**RACOLA TAILINGS DAM
WASHINGTON COUNTY, MISSOURI
MO 30475**

**PHASE 1 INSPECTION REPORT
NATIONAL DAM SAFETY PROGRAM**

SUBJECT: Racola Tailings Dam Phase I Inspection Report

PHASE I INSPECTION REPORT
NATIONAL DAM SAFETY PROGRAM
RACOLA TAILINGS DAM
ID NO. MO 30475

CREST DETAIL
 Typical where gravel is mined on dam crest

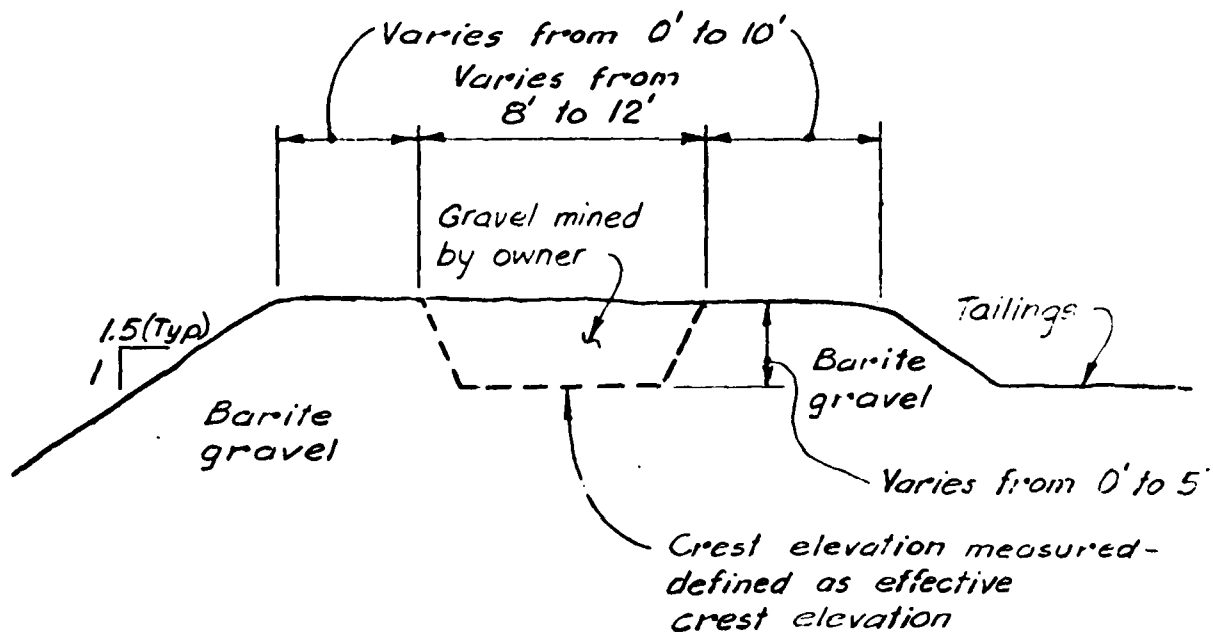
No detrimental settlement, depressions, sinkholes, animal burrows or evidence of past embankment overtopping was observed. The owner is presently excavating gravel from the crest of the dam at the southwest corner of the impoundment near the left abutment. Gravel has also been removed from these downstream embankment slopes near Stations 6+00 and 30+00 (Photo No. 7). The slope is excessively steep in these areas as a result of this mining activity. These slopes are probably at the angle of repose for the -7/8-inch barite gravels.

The location of a low point on the dam crest is complicated by the gravel mining activities on the dam crest. An elevation of 724.7 was surveyed near Station 21+60 in an excavated area (Plate 7). Crest elevations in other areas where gravel was mined were measured in a similar fashion. However, the effective crest elevation for overtopping analyses was determined after evaluating field observations and the survey.

The present owner's gravel mining activities are reducing the effective freeboard at the dam.

b. Increase in Freeboard. The practice of excavating gravel from the embankment crest, particularly near Stations 30+00+ and 21+00+ should cease immediately. These excavated areas should be refilled with similar materials to increase freeboard at the low spots of the dam.
